## **Proposal for amendments to the proposal for the 04 series of amendments to UN Regulation No. 26 (External projection for passenger cars – document GRSG/2019/34)**

### **Submitted by the expert from OICA \***

Figure 0 - Example of parts distribution

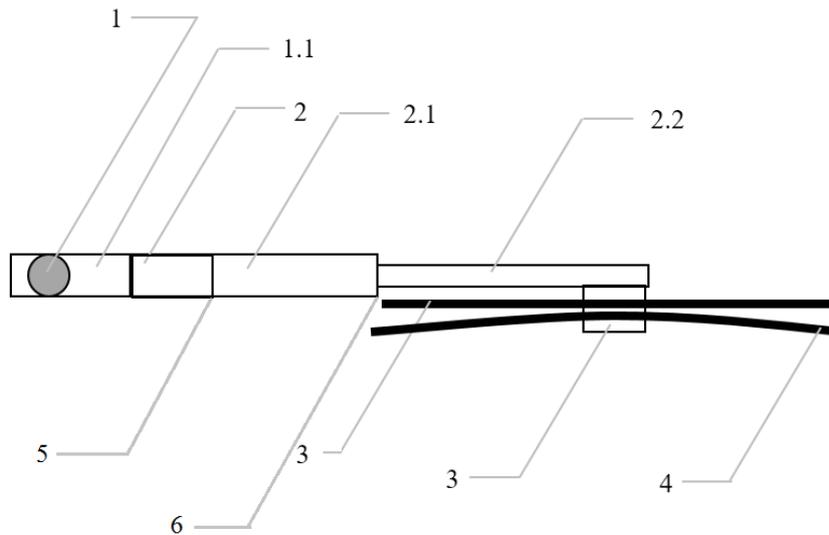
6.4.1. The windscreen wiper fittings shall be such that the wiper shaft (**number 1 in Figure 0**) is furnished with a protective casing (**number 1.1 in Figure 0**) which has a radius of curvature meeting the requirements of paragraph 5.4. above and an end surface area of not less than 150 mm<sup>2</sup>. **The holder (head and main part, i.e. numbers 2, 2.1 in Figure 0) are is designed with a radius of curvature meeting the requirements of paragraph 5.4. above.** In the case of rounded covers, these shall have a minimum projected area of 150 mm<sup>2</sup> when measured not more than 6.5 mm from the point projecting furthest. These requirements shall also be met by rear window wipers and headlamp wipers.

6.4.2. Paragraph 5.4. shall not apply to the wiper blades (**number 4 in Figure 0**), ~~or~~ to ~~any~~ supporting members (**number 3 in Figure 0**) if present, **to main part (number 2.1 in Figure 0) if present**, to second holder (**number 2.2 in Figure 0**) if present, to the functional hinge between the holder head and the holder (**number 5 in Figure 0**) if present, or to the junction between the main and the second holder (**number 6 in Figure 0**) if present. However, these units shall be so made as to have no sharp angles or pointed or cutting parts.
